**Transport Infrastructure
Development Corporation**

**North West Rail Link
Supplementary Submissions
Report**

March 2008

Figure 3.1 Ground-borne noise

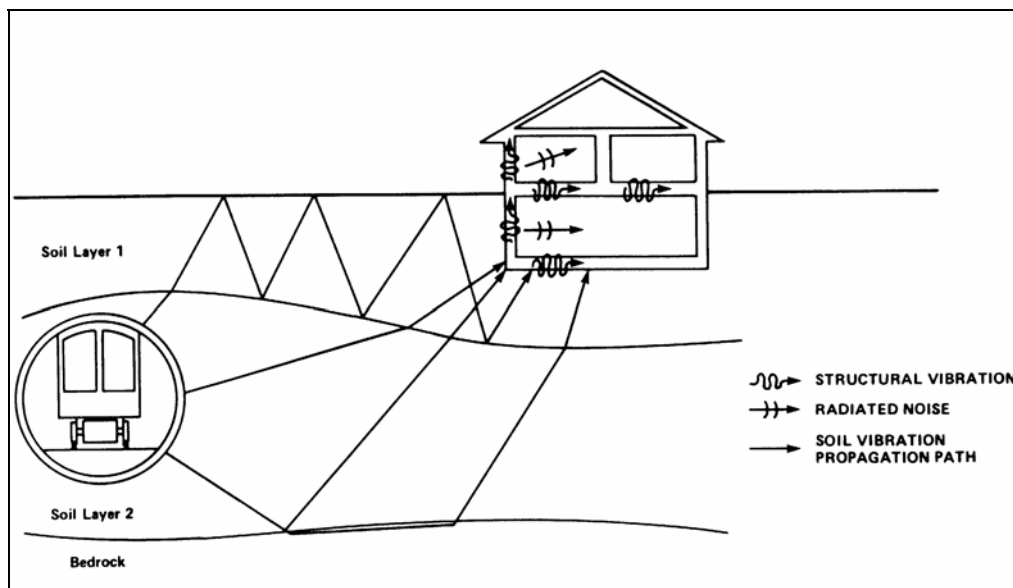
As noted in the preferred project report, ground-borne noise is created when vibrations produced at the track by trains running in the tunnels travel up through the ground and into buildings, causing flat surfaces in the building to vibrate faintly. The vibration should not be strong enough to be felt, but may create an audible noise in the building (see Figure 1 below). Ground-borne noise is also sometimes referred to as 'regenerated' or 'radiated' noise.
